Change Order # 3 data.
Format (## / ## / ##) = (Previous page total / This Page total / Over all total)
Bid item 2: Ductile 14-16' deep: 0/0/0
Bid item 3: PVC 14-16' deep: 0/0/0
Bid item 4: CIPP: 0/389/389
Bid item 7: MH 10-12' deep: 0/0/0
Bid item 30: Inlet Protection: 0/3/3

TOWN OF LANDIS
SANITARY SEWER SYSTEM REHAB
ROWAN COUNTY, NORTH CAROLINA

DRAWING NO. S-11
SHEET NO. 15

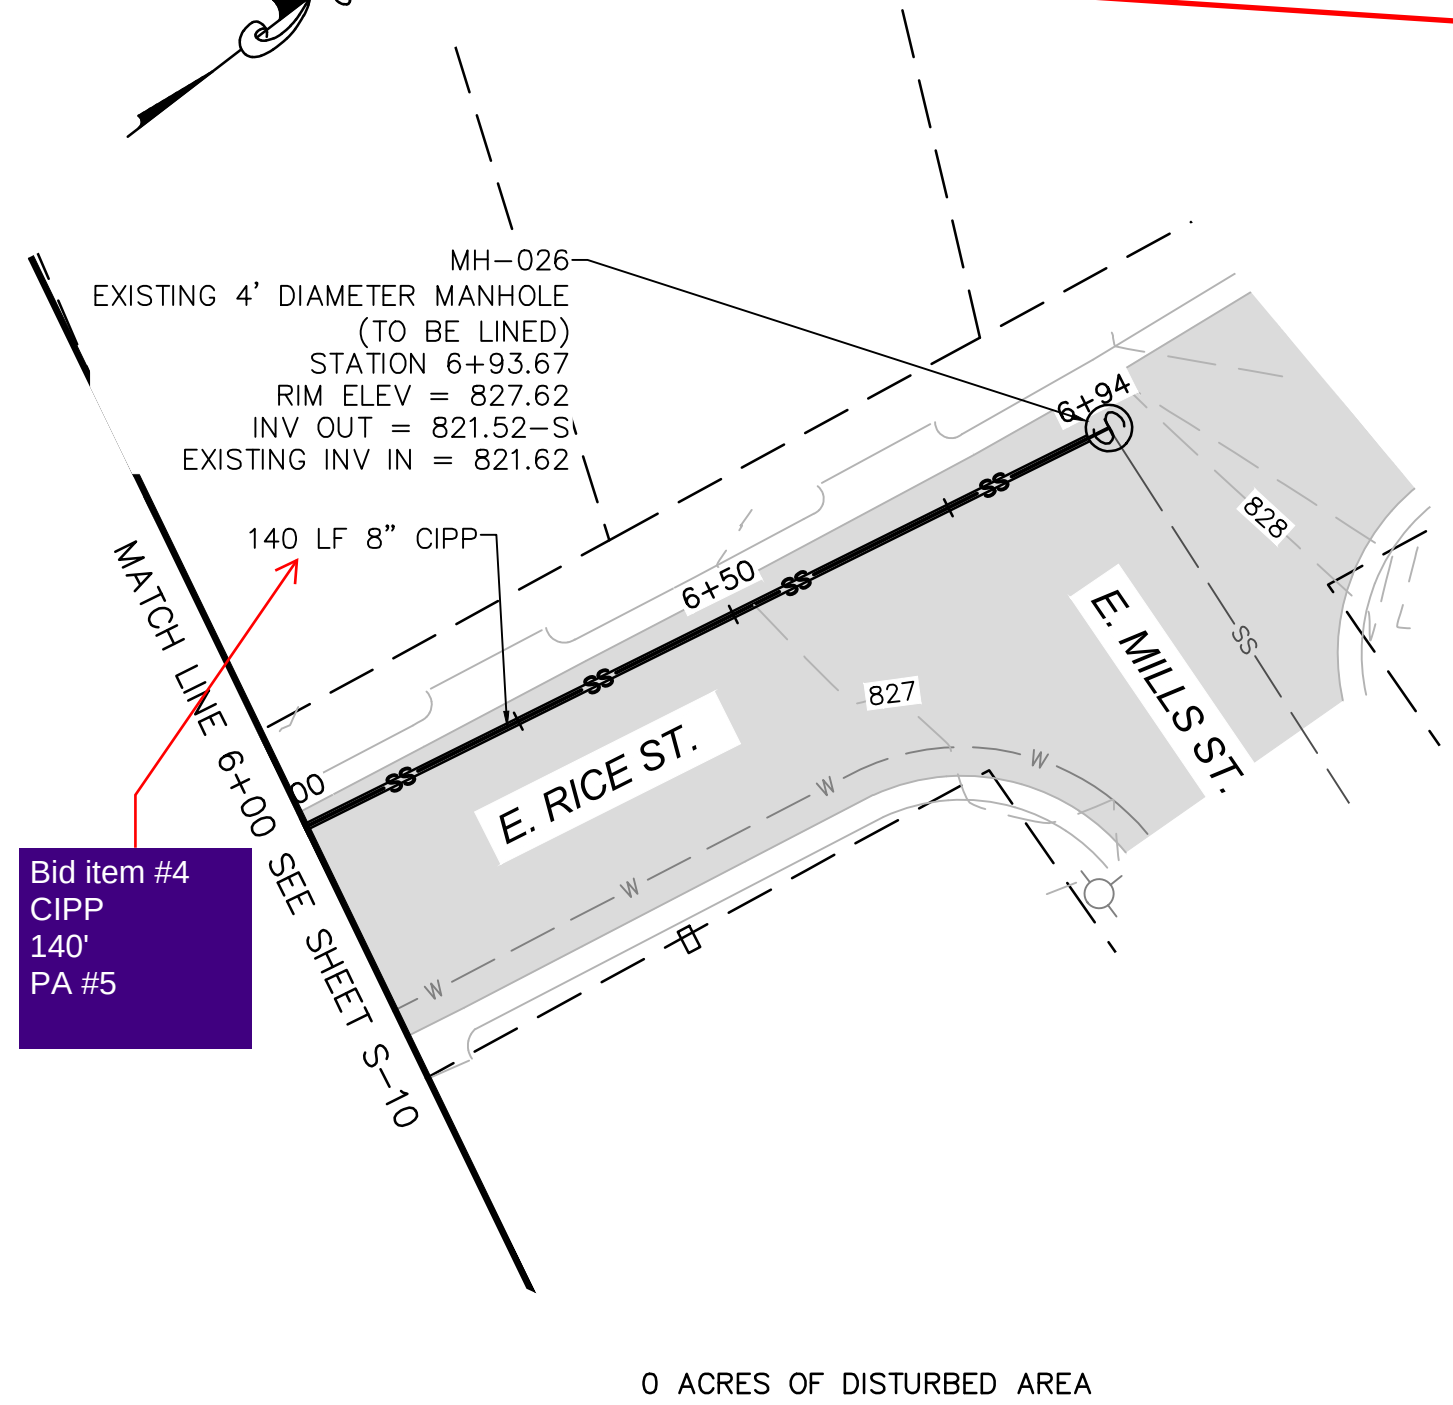
Change Order # 3 data.
Format (## / ## / ##) = (Previous page total / This Page total / Over all total)
Bid item 2: Ductile 14-16' deep: 80/0/80
Bid item 3: PVC 14-16' deep: 95/0/95
Bid item 4: CIPP: 3231/431/3662
Bid item 7: MH 10-12' deep: 2/0/2
Bid item 30: Inlet Protection: 7/0/7

Original Bid QTY:14. Requesting 66 additional feet via CO #3. New total QTY: 80
Original Bid QTY:12. Requesting 83 additional feet via CO #3. New total QTY: 95
Original Bid QTY:3357. Requesting 305 additional feet via CO #3. New total QTY: 3662
Original Bid QTY:1. Requesting 1 additional via CO #3. New total QTY: 2
Original Bid QTY:4. Requesting 5 additional via CO #3. New total QTY: 9
(I expect to have at least 2 more locations during continued construction)
